Project	IEEE 802.16 Broadband Wireless Access Working Group < http://ieee802.org/16 >	
Title	ACS procedure in Coexistence Community	
Date Submitted	2005-11-14	
Source(s)	Pan Zhong Huawei Huawei Industrial Base, Bantian, Longgang, Shenzhen 518129 P.R.C	Voice: +86-755-28971675 Fax: +86-755-28972149 panz@huawei.com
Re:	80216h-05_023: Call for Contributions IEEE 802.16's License-Exempt (LE) Task Group. 2005-10-17	
Abstract	Clarify the concept of community and proposed a efficient method for coexistence ACS	
Purpose		
Notice	This document has been prepared to assist IEEE 802.16. It is offered as a basis for discussion and is not binding on the contributing individual(s) or organization(s). The material in this document is subject to change in form and content after further study. The contributor(s) reserve(s) the right to add, amend or withdraw material contained herein.	
Release	The contributor grants a free, irrevocable license to the IEEE to incorporate material contained in this contribution, and any modifications thereof, in the creation of an IEEE Standards publication; to copyright in the IEEE's name any IEEE Standards publication even though it may include portions of this contr

Figure h29 Process of ACS

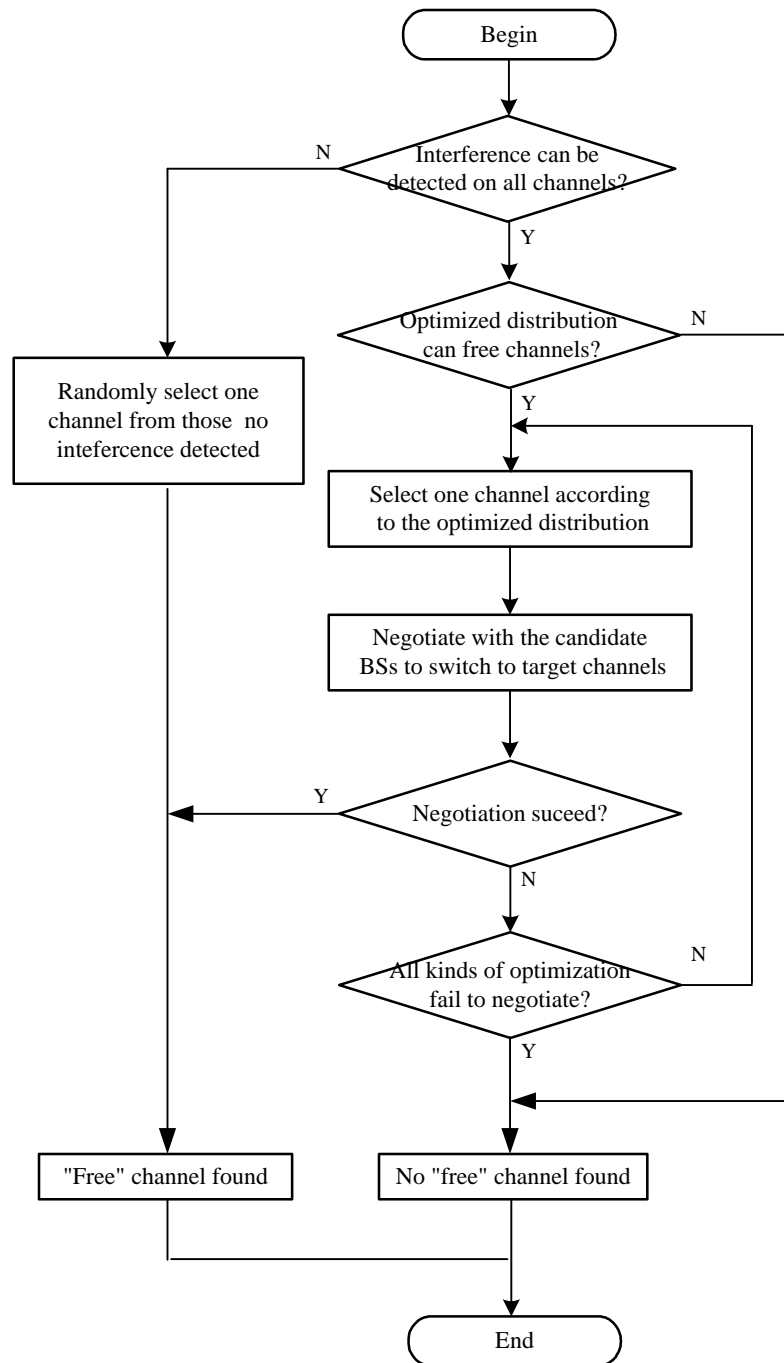
[Insert the following paragraph at the begin of 15.7.1]

15.7.1 How to select a "free" channel (for ACS and DFS)

BS should listen on multiple frequencies during the selection of working frequency. If the interference's level is greater than the detection threshold, which is the required strength level of a received signal within the channel bandwidth, the channel is considered as a interfered channel. If IBS can't find a "free" channel by scanning, it should figure out whether an indirect "free" channel can be found by optimized channel distribution, as described in 15.7.1.4.

Process of ACS is shown in Figure h29. ACS results two kinds of resolution, a "free" channel found with or without channel switching, or no "free" channel found.

If a “free” channel found, means default interference-free Master slot is available, otherwise, IBS need to share the channel with coexistence neighbors, as described in 15.2.1.7.
